DOCKET NUMBER 50-483  
UNION ELECTRIC COMPANY  
CALLAWAY PLANT  
REVISION TO TECHNICAL SPECIFICATION 3.5.5  
"SEAL INJECTION FLOW"

This amendment application would revise LCO 3.5.5, Required Action A.1, and SR 3.5.5.1 to replace the current, single-point acceptance criterion with a reactor coolant pump seal injection flow curve that is applicable throughout the LCO Applicability.

ATTACHMENT ONE  
ULNRC04583

Figure 3.5.5-1 (page 1 of 1)  
Delta P from Charging Header to RCS vs. Total Seal Injection Line Flow

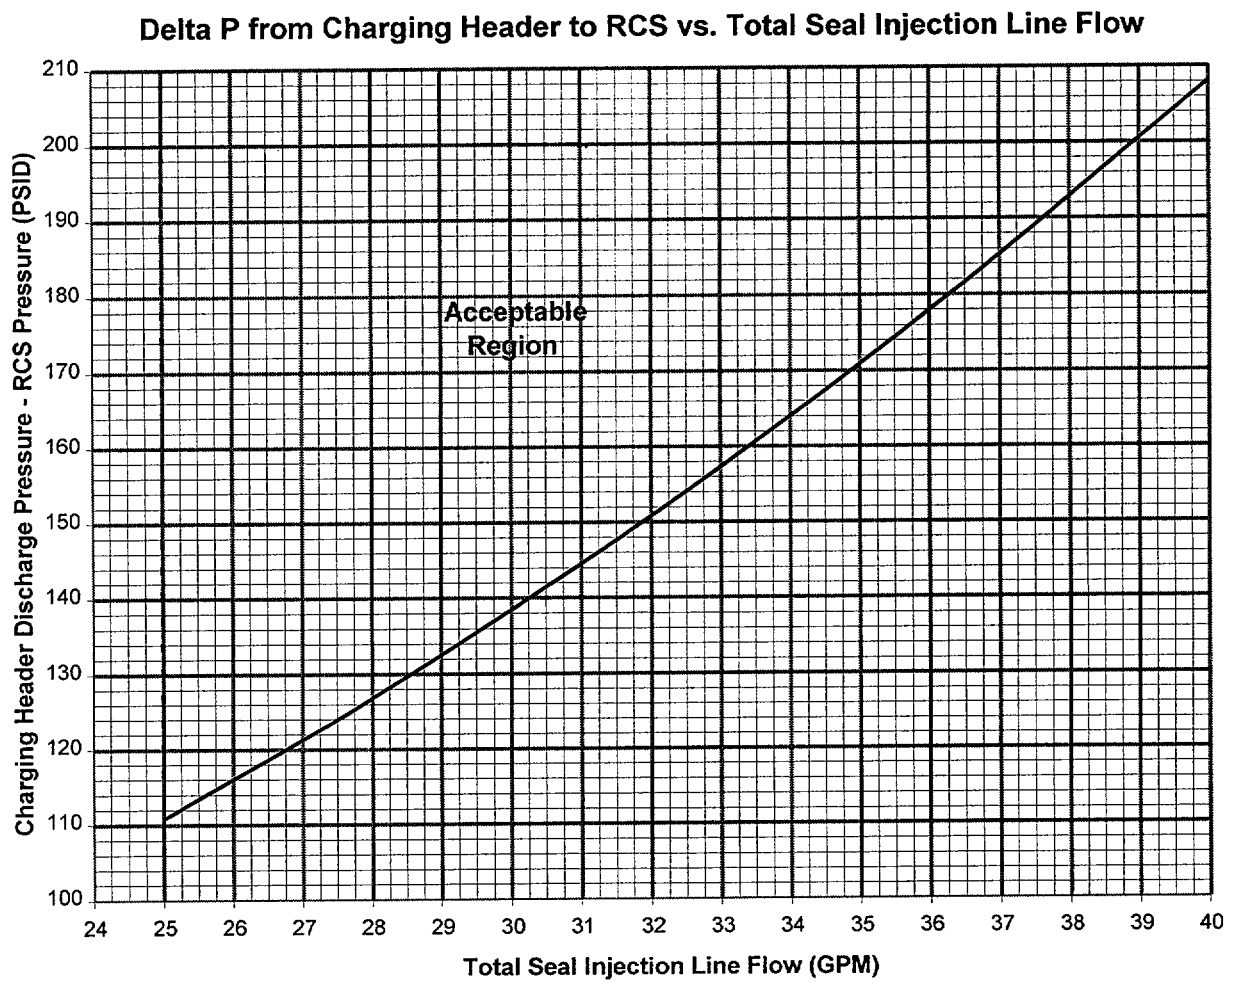
This amendment application requests that a new seal injection flow curve be incorporated into the Technical Specifications. New Figure 3.5.5-1 will be added to depict the seal injection flow limits. The following paragraphs discuss the proposed changes for each section of TS 3.5.5.

A new figure will be added. New Figure 3.5.5-1 can be applied at any time during the LCO Applicability, i.e., any time during MODES 1, 2, and 3.

The seal injection flow curve being added as TS Figure 3.5.5-1 is presented with the pressure difference from BGPT0120 to the pressurizer pressure as a function of the total seal injection line flow rate. To add conservatism for filter changes, 4 psid is added to the required pressure differential as discussed above. In addition, 2 psid is added to accommodate instrument uncertainty. A flow measurement instrument uncertainty of 0.25 gpm per loop was accounted for in the calculation of the pressure drop from BGPT0120 to the RCP seal injection connection. The minimum required pressure difference from the CCP discharge header (BGPT0120) to the pressurizer steam space pressure (average of four pressurizer pressure measurements) is calculated by the following equation:

The data points below, corresponding to a pressurizer level of 65% of span, were used to generate new TS Figure 3.5.5-1.

Total Seal Injection Line Flow, GPM	Flow per RCP, GPM	$\Delta P$ Charging Pump Discharge Header to RCS, PSIG
25	6.25	110.8
28	7	126.8
32	8	150.8
36	9	178.0
40	10	208.2

shall be within the limits of Figure 3.5.5-1.

such that the RCP seal injection flow is within the limits of Figure 3.5.5-1.

the limits of Figure 3.5.5-1.

Figure 3.5.5-1 (page 1 of 1)  
Delta P from Charging Header to RCS vs. Total Seal Injection Line Flow

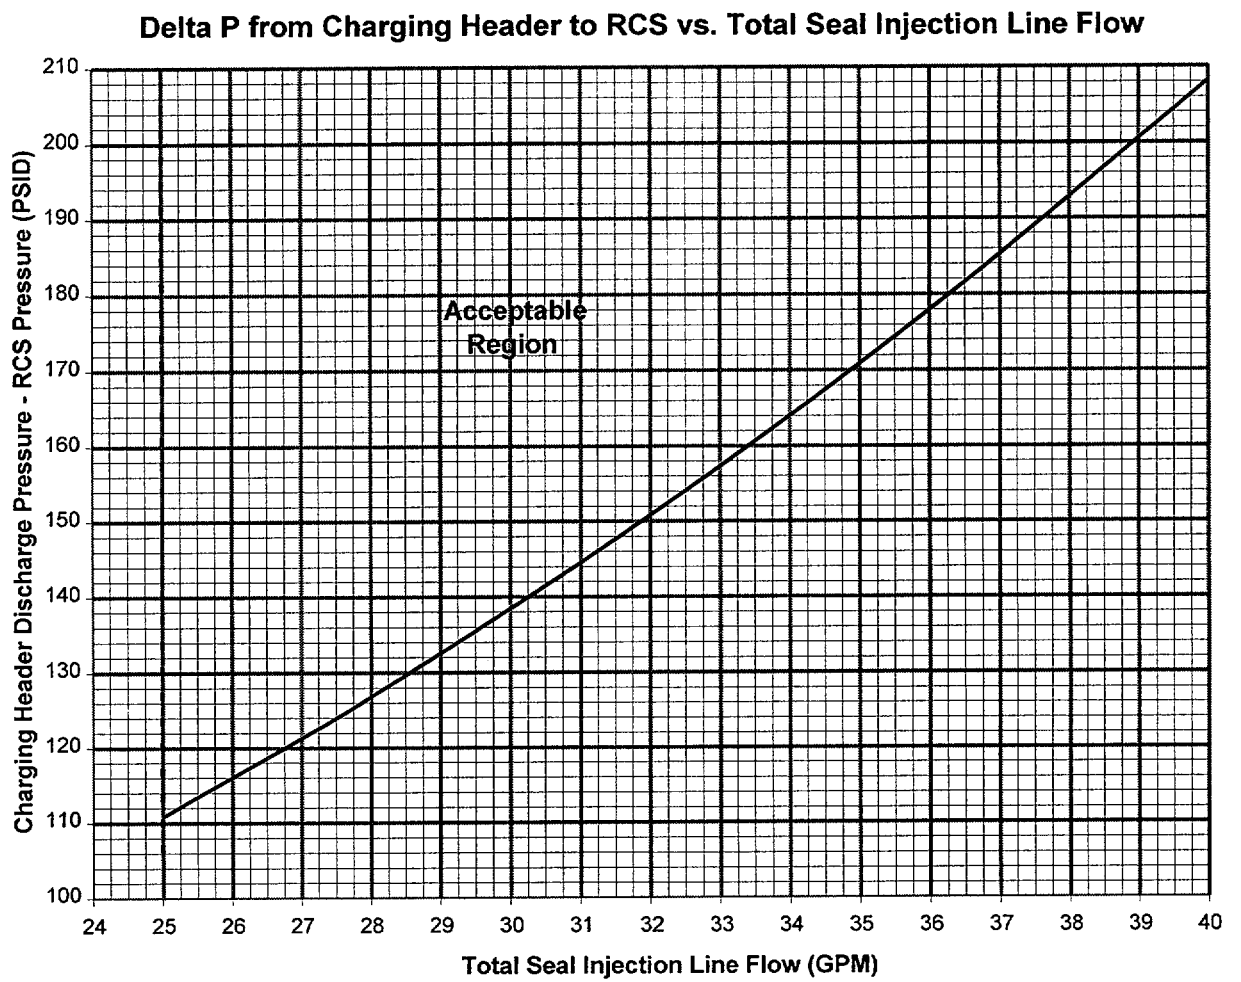
LCO 3.5.5      Reactor coolant pump (RCP) seal injection flow ***shall be within the limits of Figure 3.5.5-1.***

CONDITION	REQUIRED ACTION	COMPLETION TIME
A. Seal injection flow not within limit.	A.1      Adjust manual seal injection throttle valves <b><i>such that the RCP seal injection flow is within the limits of Figure 3.5.5-1.</i></b>	4 hours
B. Required Action and associated Completion Time not met.	B.1      Be in MODE 3.	6 hours
	<u>AND</u> B.2      Be in MODE 4.	12 hours
